UNITED STATES PATENT AND TRADEMARK OFFICE

APPLICATION NO.	FILING DATE	FIRST NAMED INVENTOR	ATTORNEY DOCKET NO.	CONFIRMATION NO.
10/065,489	10/23/2002	Roy Edward Rand	124365	7330

Office Action Summary	Application No. 10/065,489	Applicant(s) RAND, ROY EDWARD	
	Examiner Phillip A Johnston	Art Unit 2881

Detailed Action

FIG.-3

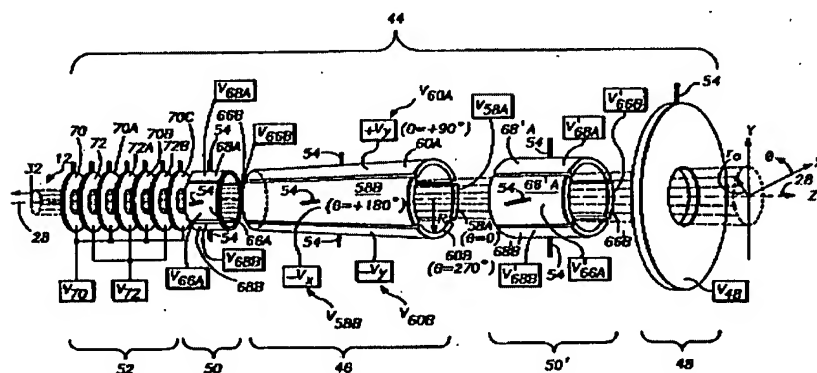
As well as, Column 11, line 36-46 in 5,193,105, which states; As shown in FIG. 3, ICE 50's elements 66A, 66B, 68A and 68B are coupled, respectively, to potential sources V_{66A} , V_{66B} , V_{68A} and V_{68B} , and the elements of ICE 50', 66'A, 66'B, 68'A and 68'B are respectively coupled to potential sources V'_{66A} , V'_{66B} , V'_{68A} and V'_{68B} . As disclosed in the above patent to Rand, et al., by suitably selecting the magnitudes of the potential sources to which the ICE electrodes are coupled, ICEs 50, 50' can be made to sweep away positive ions, while maintaining a uniform electric field.

Accordingly, it is preferred that $V_{68A} \approx V'_{68A} \approx -1.5$ kV, $V_{68B} \approx V'_{68B} \approx 0$ V (e.g., ground), $V_{66A} \approx V_{66B} \approx V'_{66A} \approx V'_{66B} \approx 0.5(V_{68A}) \approx -750$ V. V'_{68A} and V'_{68B} may also be reversed. Potential V_{68A} could, however, be other than -1.5 kV, with the other electrode potentials being changed accordingly.

And Figure 3 in 5,193,105, attached below;

The examiner has interpreted from the Rand (445) references above that a grounded tube 50' and an ion trapping region 46 are used in the downstream region to allow ions to accumulate therein, as recited in claims 1,7,17, and 19.
